REMARKS

AMENDMENTS TO THE DRAWINGS

Please replace drawing sheets 3/12 and 9/12-12/12 with the attached replacement sheets 3/12 and 9/12-12/12 consisting of Figures 5, 6, and 12-16B.

FIG.5

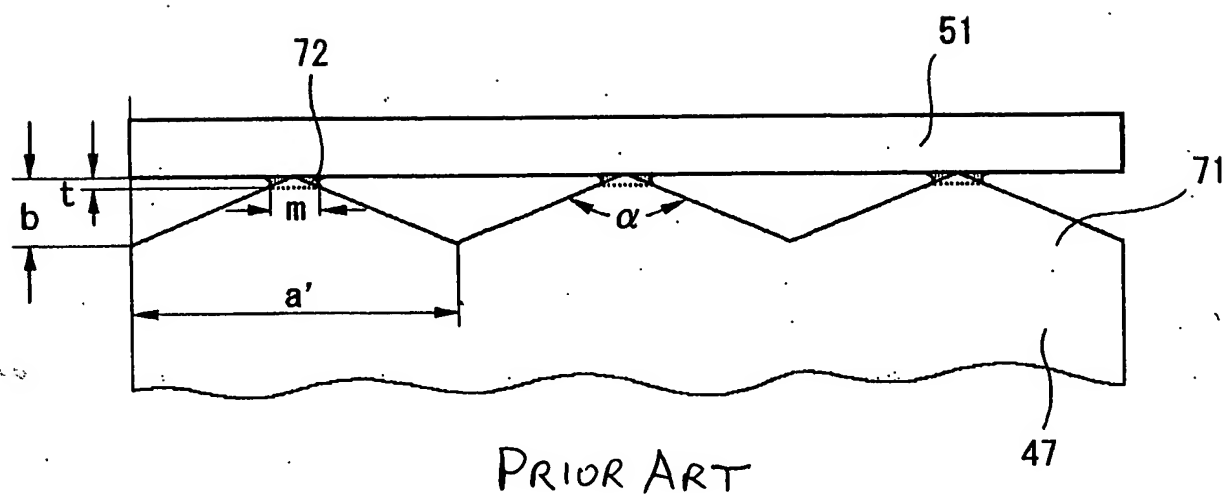
Applicant requests withdrawal of the objection to the drawings. Figures 5 and 12-16A have been amended to include the indication of "PRIOR ART" per the Examiner's recommendation. An indication of prior art has not been added to Figure 16B because Figure 16B relates to performance of the apparatus of the present invention. See e.g., paragraph [0044] in the Brief Description of the Drawings section of the specification.

Along with a replacement drawing sheets 3/12 and 9/12-12/12, a marked copy of these sheets showing the "PRIOR ART" additions to Figures 5 and 12-16A in red is included for the Examiner's approval.
